SUBJECT: Responds to 880518 & 0622 request for addl info re anticipated transients w/o scram.

Re: St. Lucie Plant Unit Nos. 1 and 2
Docket Nos. 50-335 and 50-389
Request for Additional Information
Anticipated Transients Without Scram

FLORIDA POWER & LIGHT COMPANY
ST LUCIE PLANT - UNITS 1 & 2
ATWS: RESPONSES TO NRC QUESTIONS
OF MAY 18 and JUNE 22, 1988

FIGURE 10

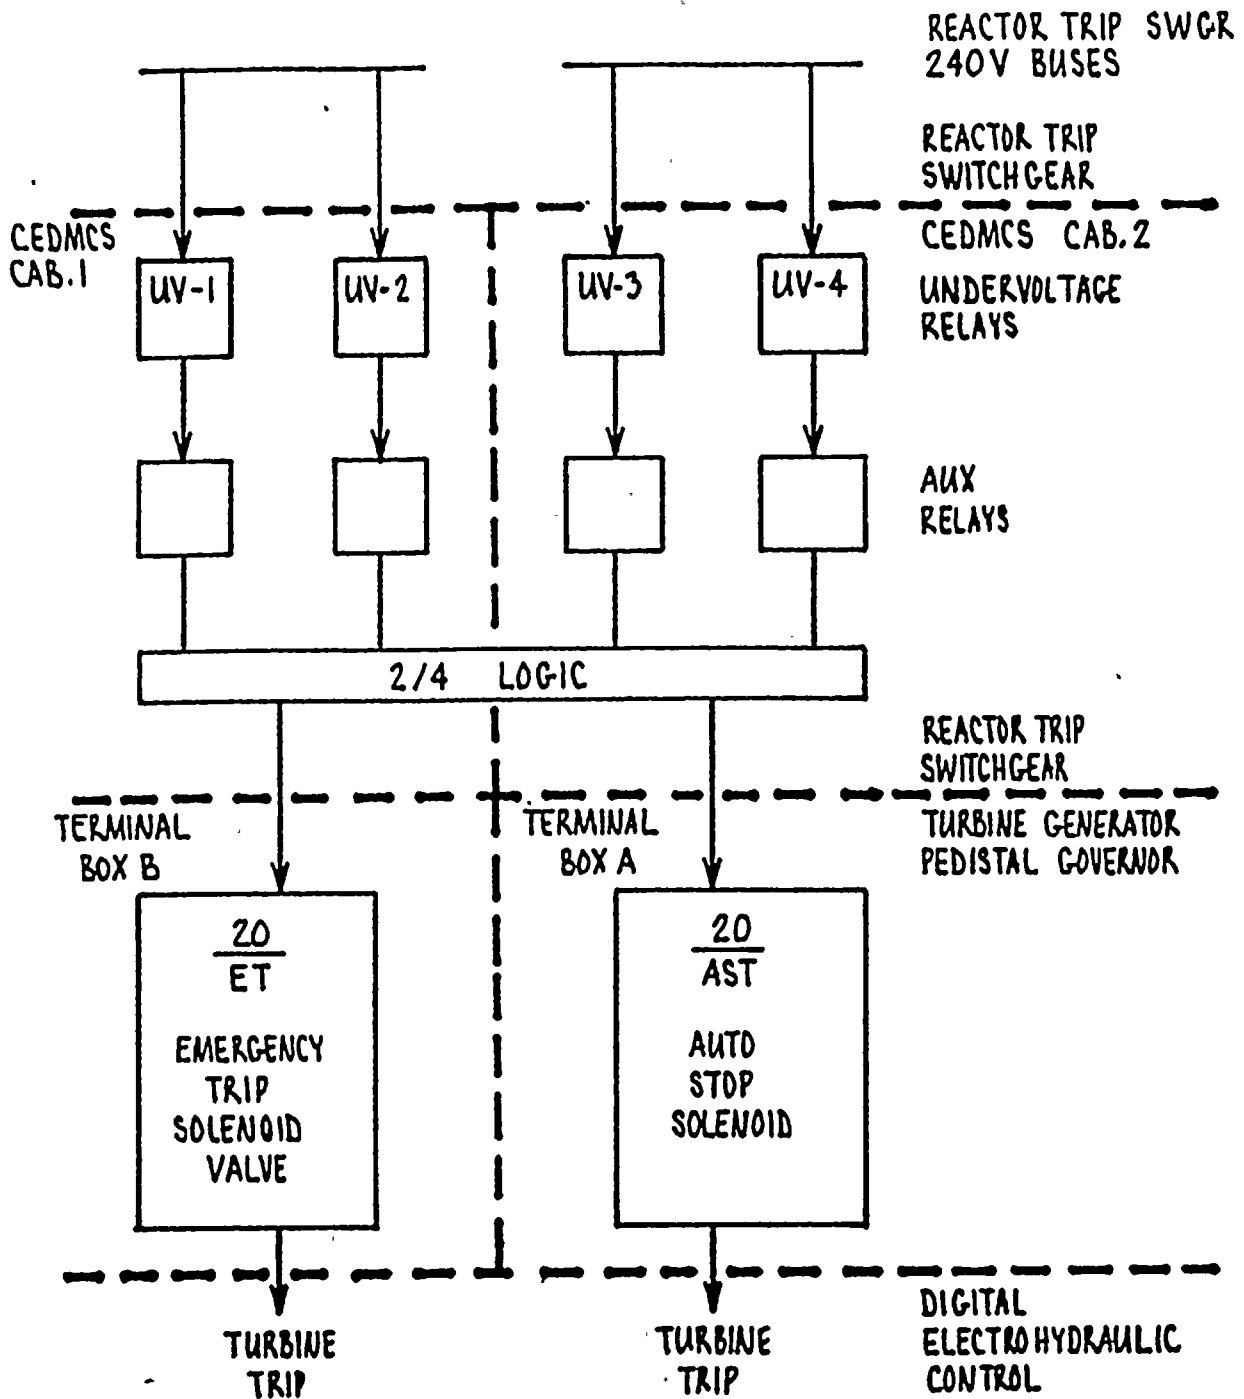
FPL's July 15, 1987 letter states that inherent to the DSS design is a turbine trip independent and diverse from the RPS, which is initiated by undervoltage conditions sensed in the CEA drive control system. Explain in detail how this arrangement satisfies the ATWS rule requirements for a diverse turbine trip. Please provide electrical schematic/elementary diagrams of the DTT circuits.

The existing turbine trip is diverse from the RPS in that the actuation of the turbine trip is based on an undervoltage condition in the reactor trip switchgear and is not based on the RPS logic. This assumes that there is an operational DSS which causes the undervoltage condition regardless of the status of the reactor trip breakers. As can be seen in the one-line diagrams in Figures 9 and 10, there are four voltage sensing devices (different devices for each Unit) that are fed into two 2/4 logic circuits, which in turn actuate to the auto trip solenoid and emergency trip solenoid valve to release auto stop hydraulic oil and emergency trip hydraulic oil, respectively. Loss of hydraulic oil pressure from either source will cause a turbine trip.
